SUBJECT: SEISMIC QUALIFICATION OF EMERGENCY FEEDWATER SYSTEM

Re: Oconee Nuclear Station, Units 1, 2 and 3

REQUEST FOR INFORMATION
OCONEE NUCLEAR PLANT, UNITS 1, 2 AND 3
050-269, 270 AND 287

Response to the NRC Request for Information on
Seismic Qualification of the Auxiliary Feedwater System

LPSW SYSTEM

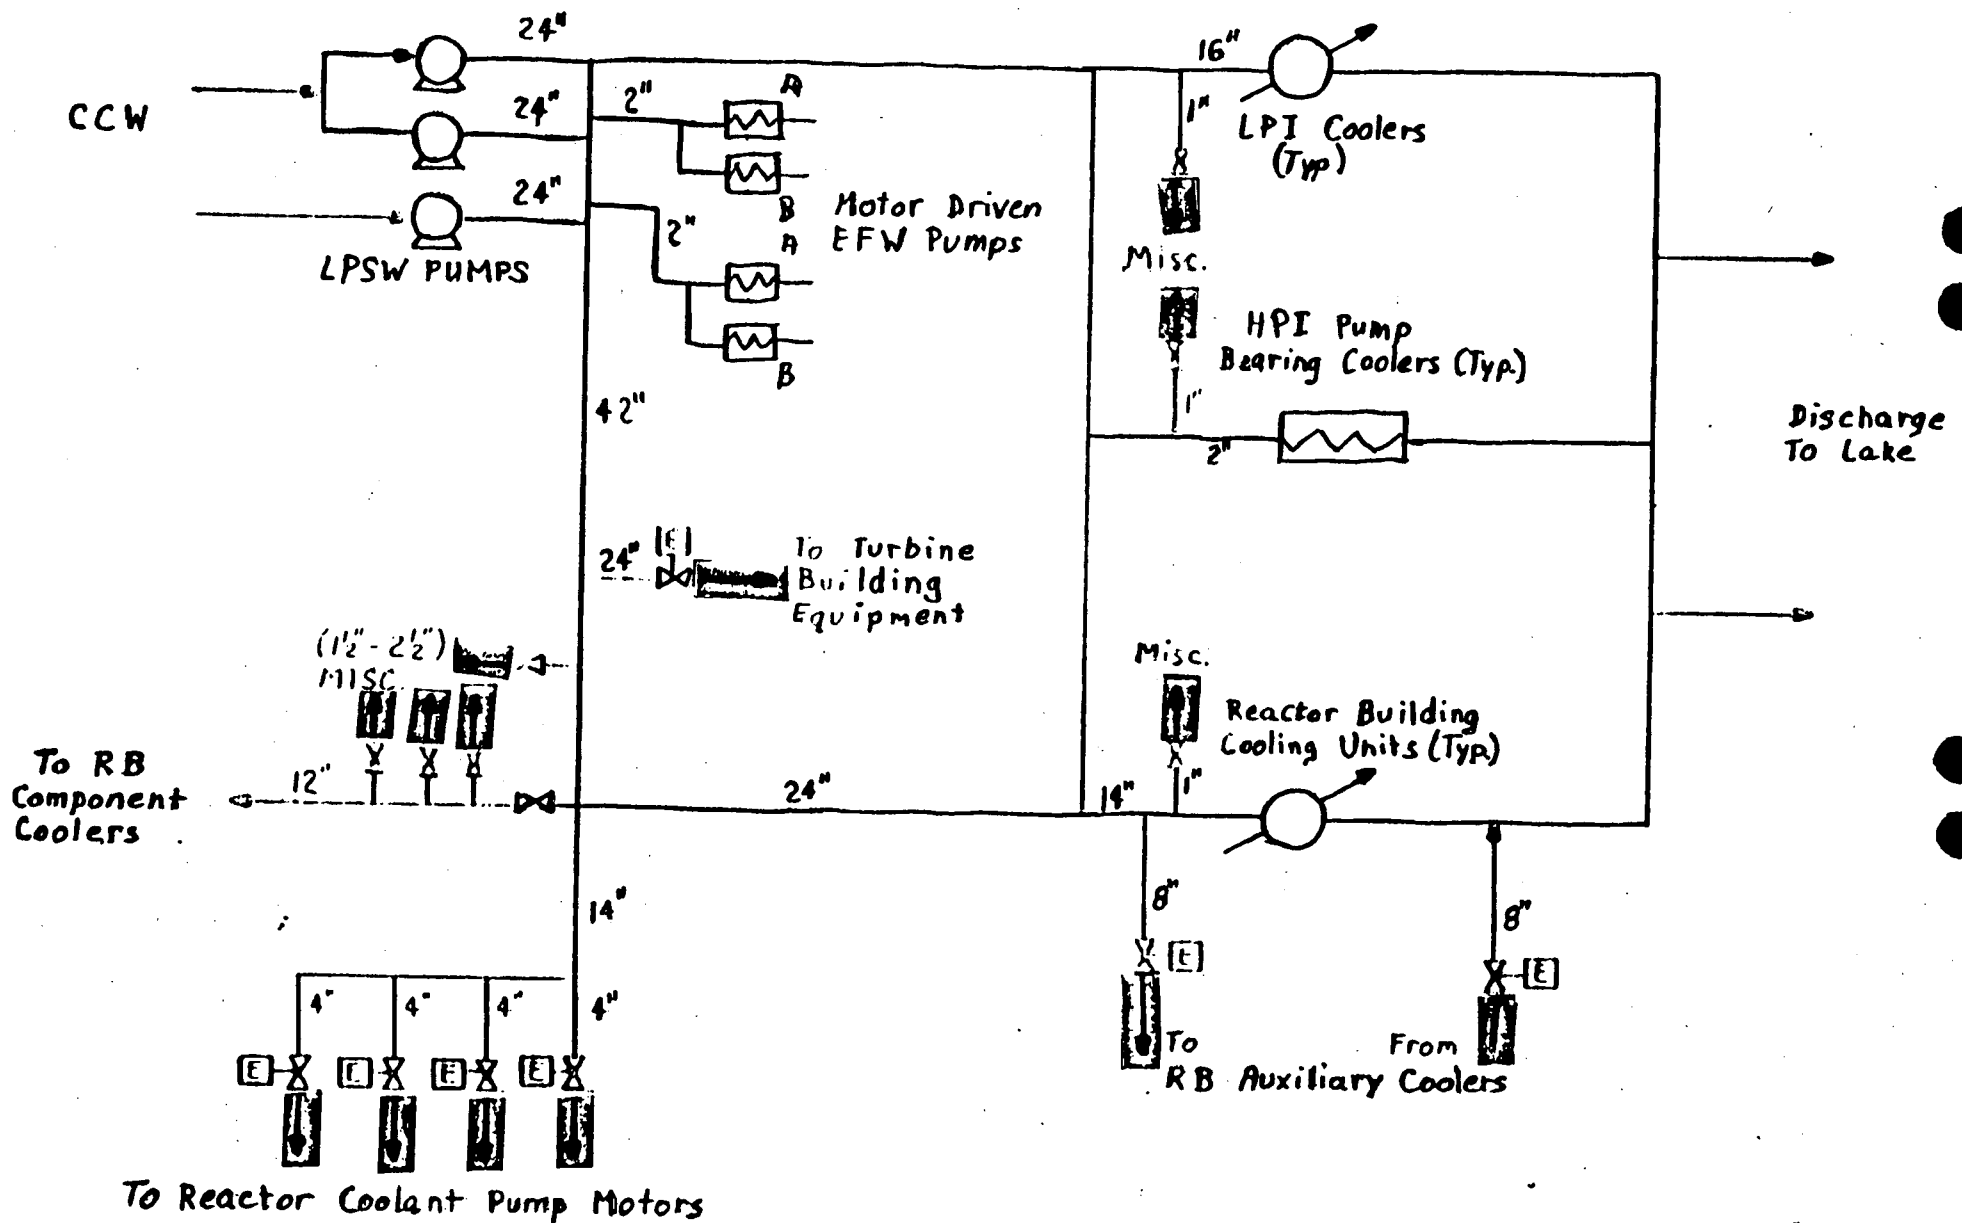
3. The low pressure service water system (LPSW) provides cooling water to the two electric motor driven pumps in the auxiliary feedwater system. Portions of the system are seismically qualified and other portions have no safety function. The safety-related portions of the system are designed to operate even with the non-safety portions operating, so several isolation valves between these positions are normally open. This statement is acceptable only if the non-safety related portions remain intact after a seismic event; therefore, either verify by analysis that these lines can withstand an SSE or verify that the failure of these lines will not result in the loss of the auxiliary feedwater system function.

3. "The Low Pressure Service Water System (LPSW) provides cooling water to the two electric motor driven pumps in the auxiliary feedwater system. Portions of the system are seismically qualified and other portions have no safety function. The safety-related portions of the system are designed to operate even with the non-safety portions operating, so several isolation valves between these portions are normally open. This statement is acceptable only if the non-safety related portions remain intact after a seismic event; therefore, either verify by analysis that these lines can withstand an SSE or verify that the failure of these lines will not result in the loss of the auxiliary feedwater system function."

- COOLS NUMEROUS SYSTEMS; PORTIONS ARE SSE QUALIFIED & OTHERS HAVE NO SAFETY FUNCTION
- EFW PORTION QUALIFIED
- NON-SAFETY PORTION PER ANSI B31.1
- CAPABLE OF SSE, THOUGH NO DETAILED ANALYSIS
- INDUSTRY EXPERIENCE
- SQUG RESEARCH
- ADDED ASSURANCE: SEVEN TRAINS OF FEEDWATER, HPSW BACKUP

Response: The LPSW System is judged to be capable of withstanding an SSE and supporting the EFW function even though this is not verified by detailed analysis. Flexibly supported piping systems are naturally resistant to failure due to seismic loading. Industry experience* has shown flexible piping systems (including those designed and supported in accordance with ANSI B31.1) are extremely resistant to damage by earthquakes of a magnitude several times larger than the Oconee SSE. The Oconee LPSW System is a flexible piping system, is designed and supported in accordance with ANSI B31.1, and is considered fully satisfactory for an SSE event.
